SUBJECT: EMPLOYEE CONCERN REGARDING VIOLATION OF QUALITY ASSURANCE PROCEDURES BY THE DIVISION OF CONSTRUCTION AT SEQUOYAH NUCLEAR PLANT - NUCLEAR SAFETY REVIEW STAFF REPORT NO. I-83-21-SQN

SUBJECT: BELLEFONTE NUCLEAR PLANT - FOLLOW-UP REVIEW - NUCLEAR SAFETY REVIEW STAFF
(NSRS) REPORT NO. R-83-25-BLN

SUBJECT: Follow-up Review of Bellefonte Nuclear Plant

Figure 4.1 Scram discharge volume dose rates in reactor building for slow depressurization cases

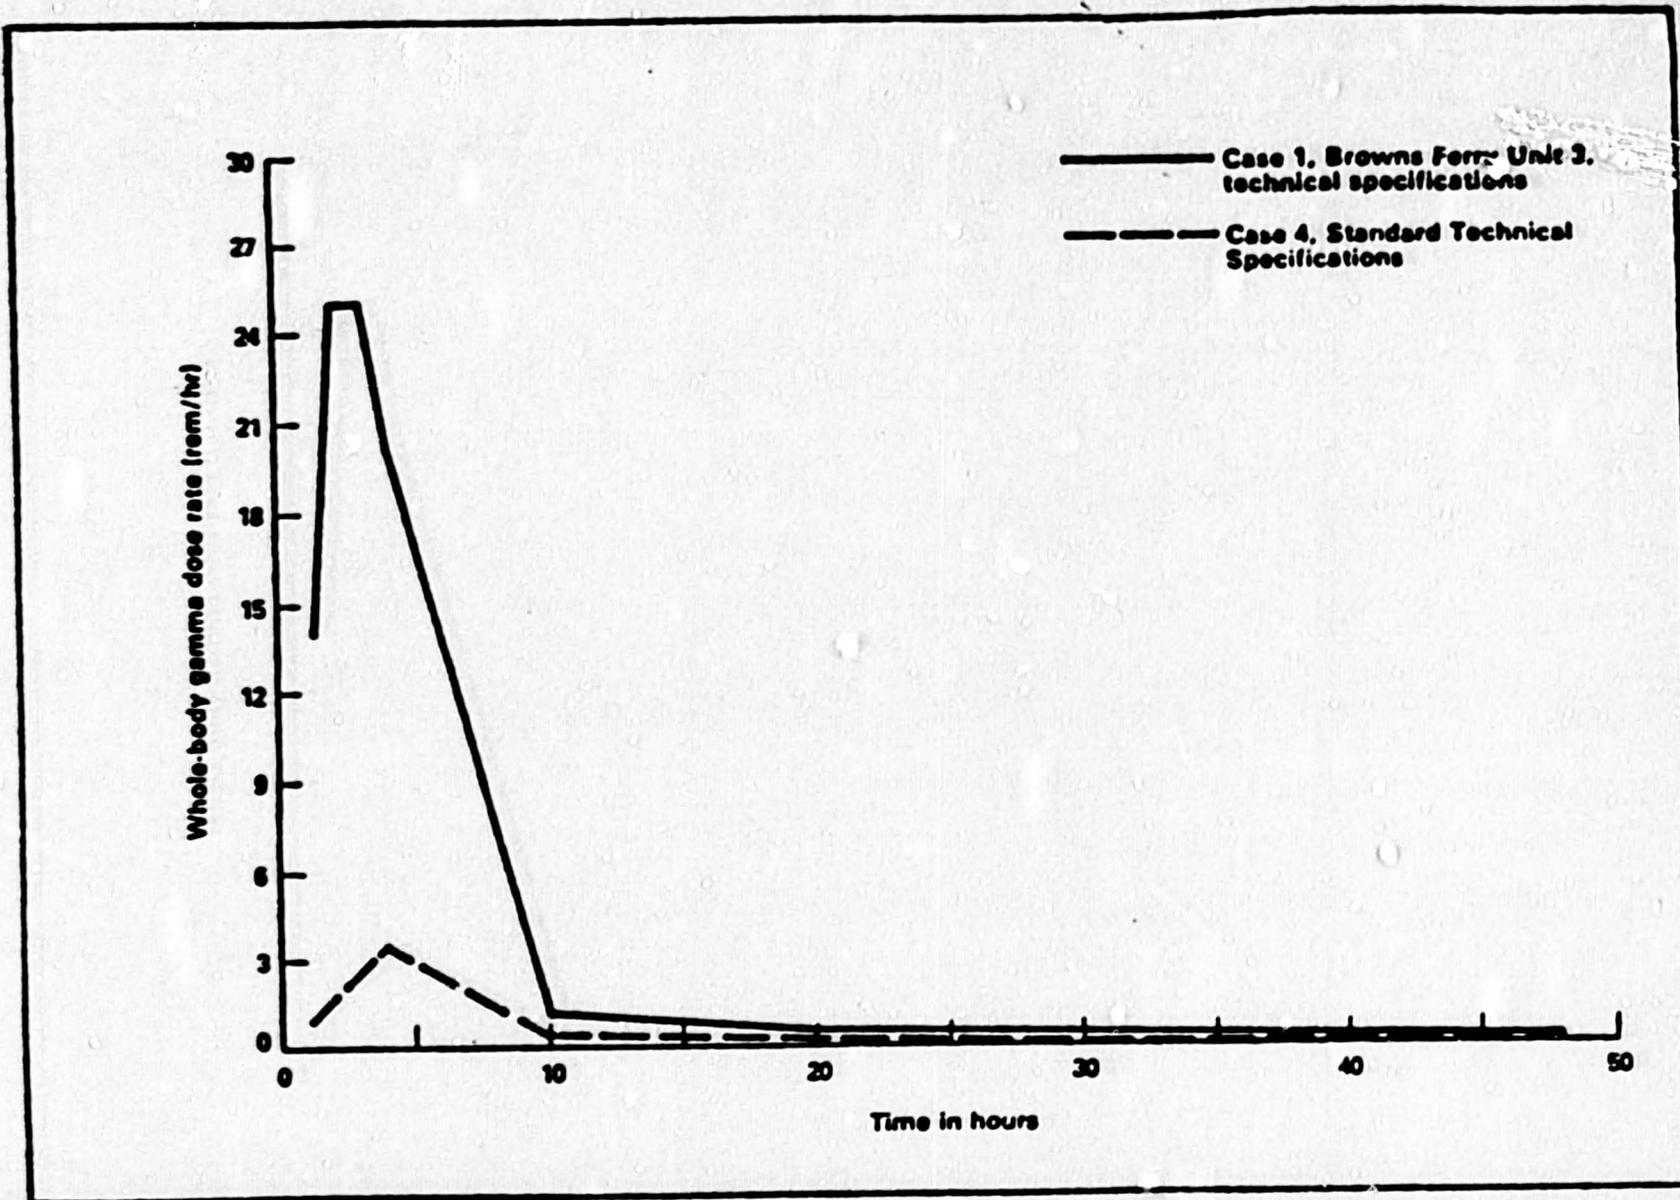
NSRS believes that there is no potential benefit to TVA in maintaining the present BFN Technical Specification limit at the current values, and operating at those levels would only serve to increase the plant radiation levels, increase radiation doses to plant personnel and the general public at the time of an accident, and make it more difficult for operating personnel to mitigate accidents involving loss of reactor coolant with subsequent contamination of the reactor building atmosphere.

This item remains open until the STS limiting conditions for operation for DEI-131 and a more meaningful surveillance sampling and analysis program for DEI-131 have been adopted and implemented and the BFN Technical Specifications have been upgraded to reflect the new program. These changes would be consistent with TVA's policies for nuclear safety and radiation protection.
